PCN-20210219 TE0745-02 DDR3 Change and Product Update

Company	Trenz Electronic GmbH
PCN Number	PCN-20210219
Title	TE0745-02 DDR3 Change and Product Update
Subject	BOM change
Issue Date	2021-03-09

This change affects all Trenz Electronic TE0745 SoMs of revision 02: TE0745-02-*

#4 Set S/N to not fitted

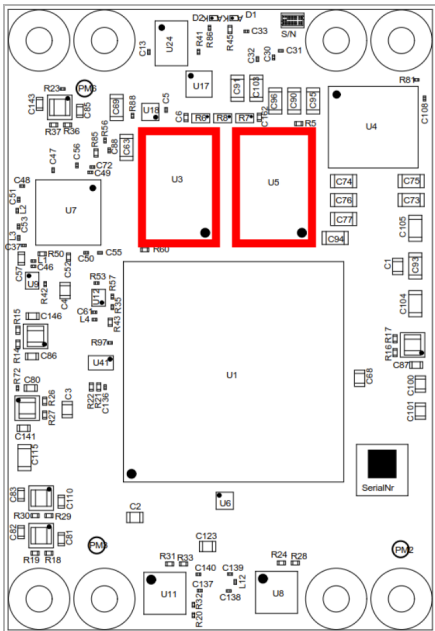
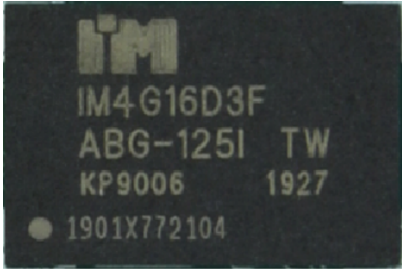
Type: BOM change

Reason: Part is end of life.

Impact: Track it pad no more available. Pin 20 of CPLD was connected via S/N to GND and is now floating. However pin is not used in delivery CPLD Firmware, so no further impact.
